Responses-to-Comments

Temporary Public Vehicle Park (Excluding Container Vehicles) for a Period of 5 Years in
'Village Type Development' Zone, Lot 1422 RP (Part) in D.D. 83, Lung Yeuk Tau, Fanling, N. T.

(Application No. A/NE-LYT/824)

Project No. 83015	Rev.
Dwg No. Figure 1	-

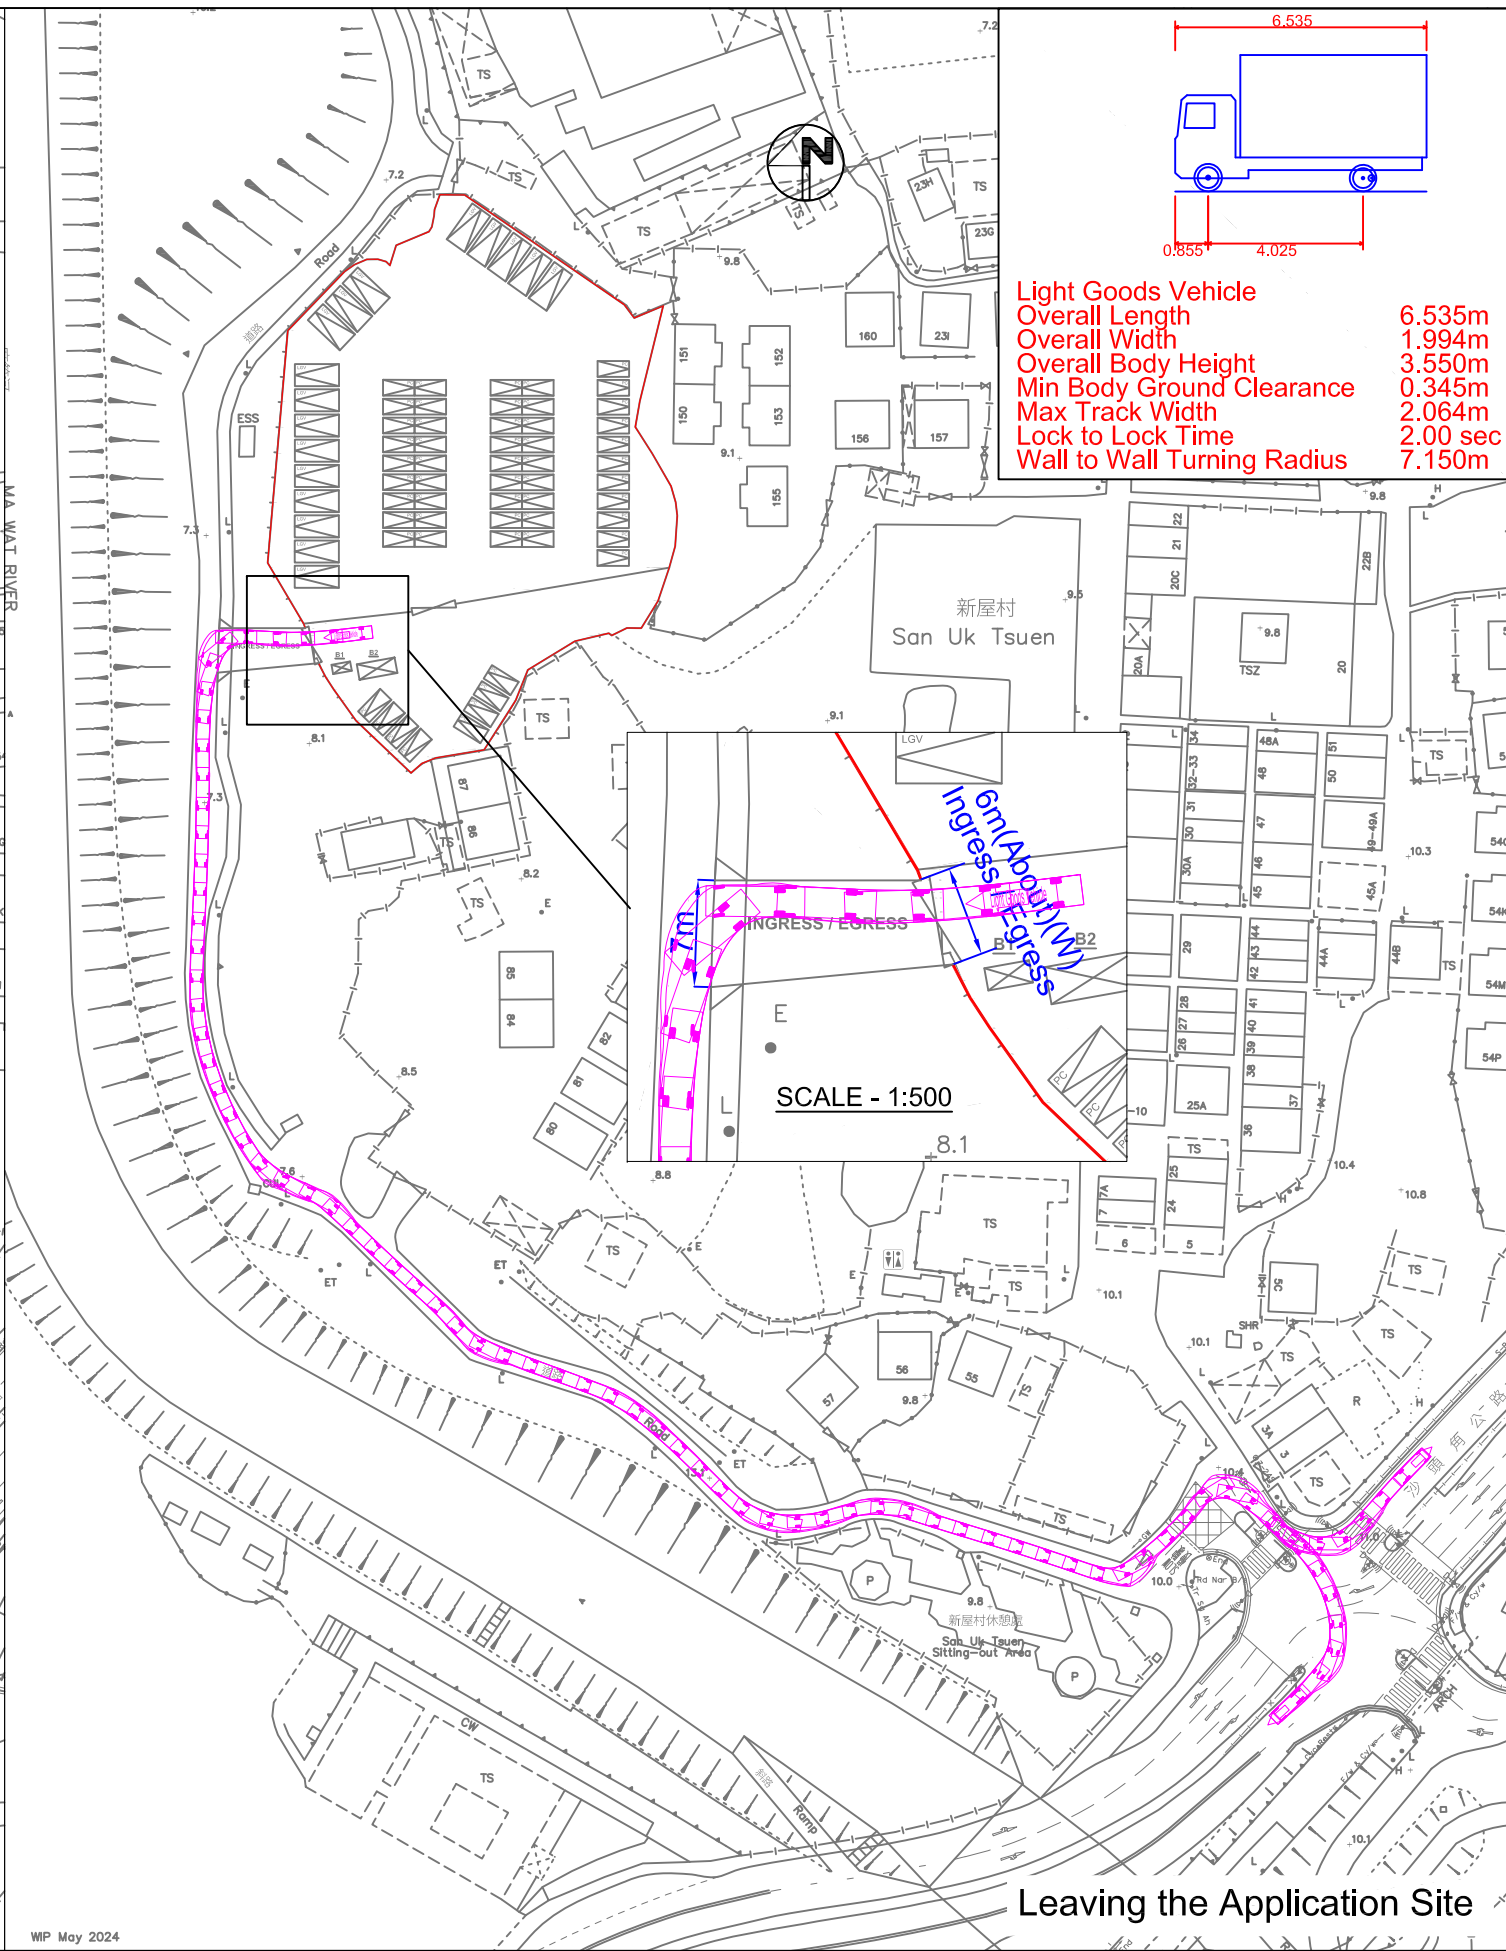
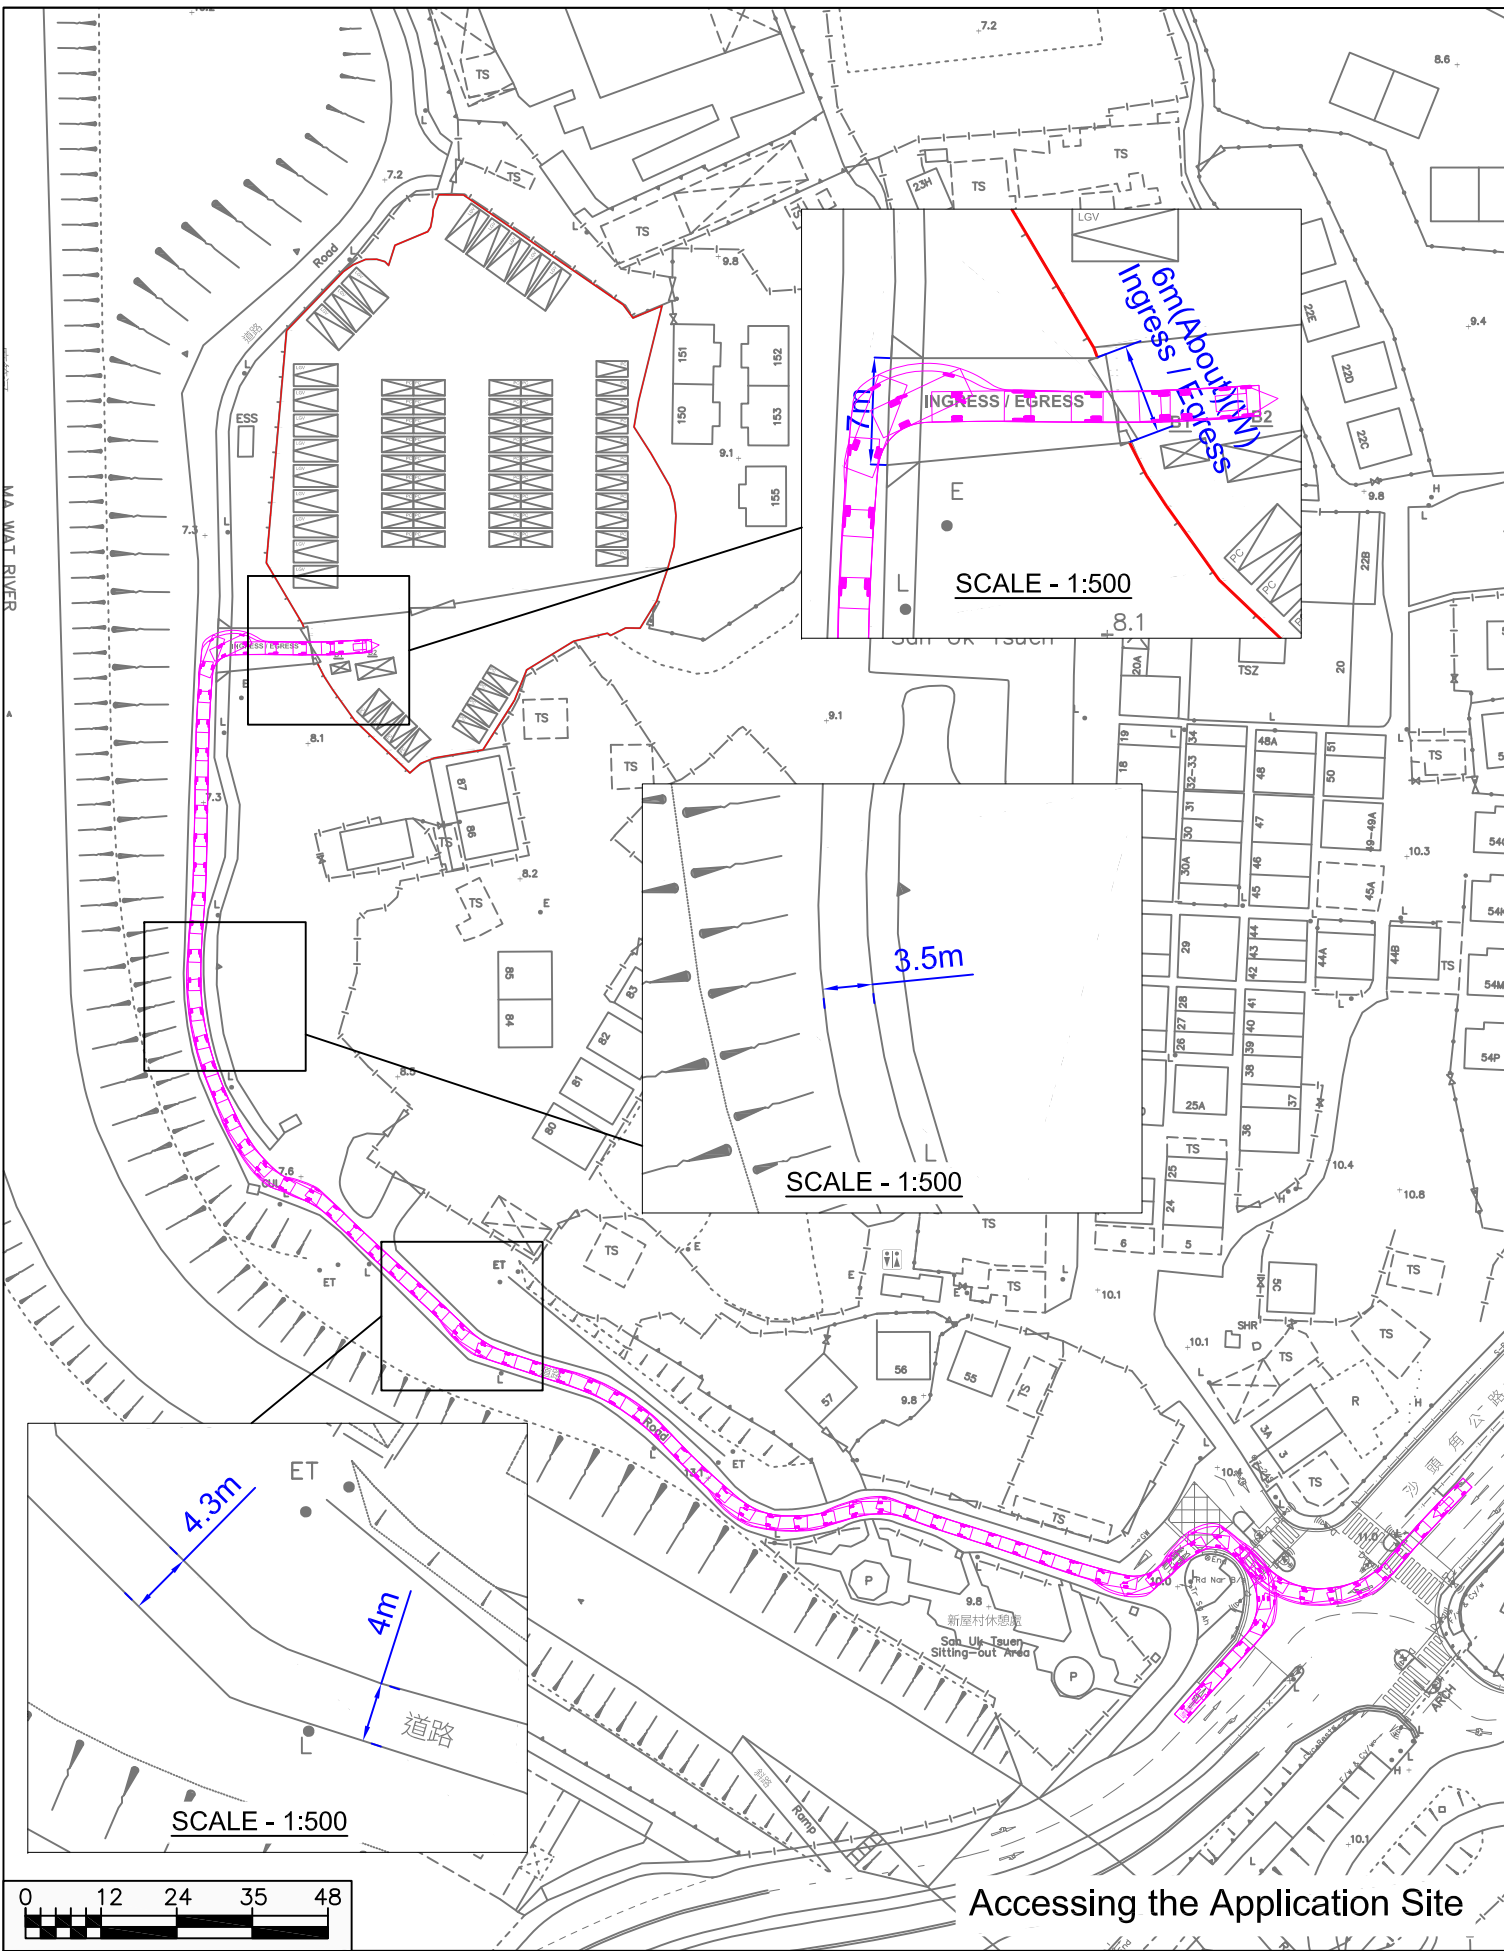
the subject site (including the maneuvering from and to Sha Tau Kok Road - Lung Yeuk Tau), preferably using the swept path analysis;	The swept path indicates that the LGV can entering to and exiting from the subject site smoothly, and enough spaces are provided within the Site. Furthermore, the swept path indicates that the LGV could manage to drive through the village road to and from Sha Tau Kok Road.
